UNITED STATES  
NUCLEAR REGULATORY COMMISSION  
WASHINGTON, D. C. 20555

ARKANSAS NUCLEAR ONE, UNIT 1

AMENDMENT TO FACILITY OPERATING LICENSE

Amendment No. 85  
License No. DPR-51

Figure 6.2-1 Management Organization Chart

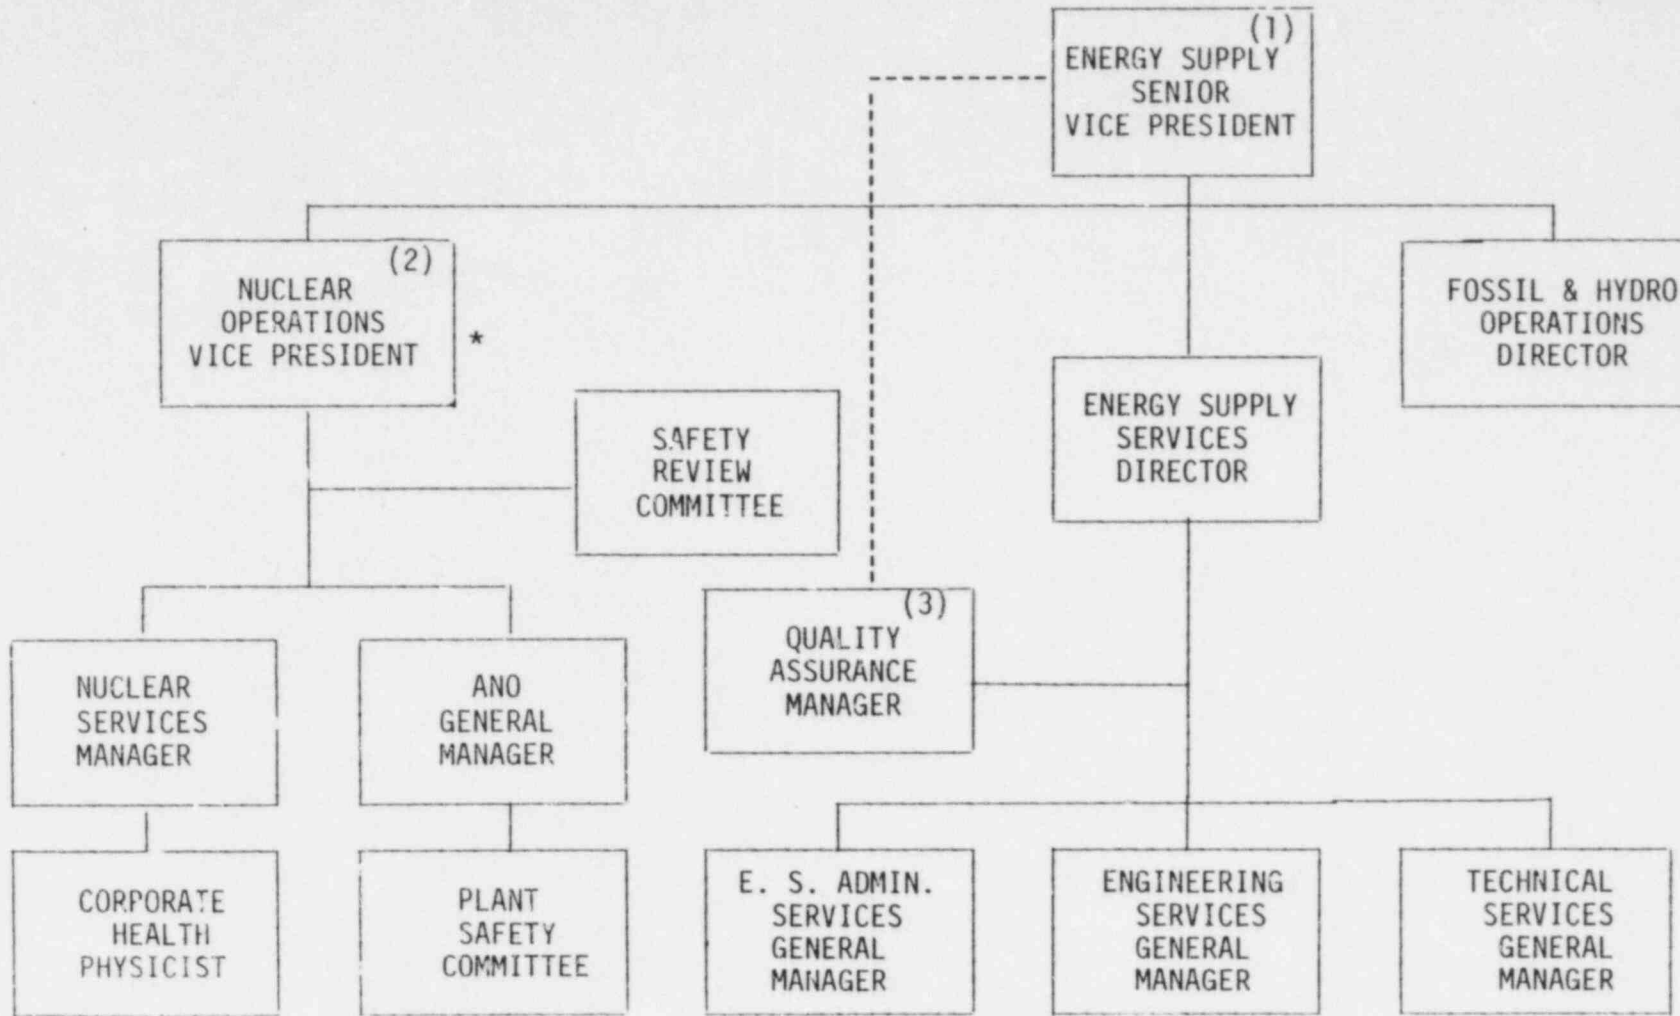
- (1) The Energy Supply Senior Vice President is on a temporary leave of absence from AP&L, serving as the Senior Vice President of Nuclear Operations for Louisiana Power and Light Company. During this absence, Mr. J. D. Phillips, Senior Vice President will assume senior management of the Energy Supply Department reporting directly to the President and Chief Executive Officer.
- (2) In the absence of the Energy Supply Senior Vice President, the Nuclear Operations Vice President will report directly to the President and Chief Executive Officer.
- (3) The Quality Assurance Manager will report (dashed line function) to the Vice President, Nuclear Operations during the absence of the Energy Supply Senior Vice President.
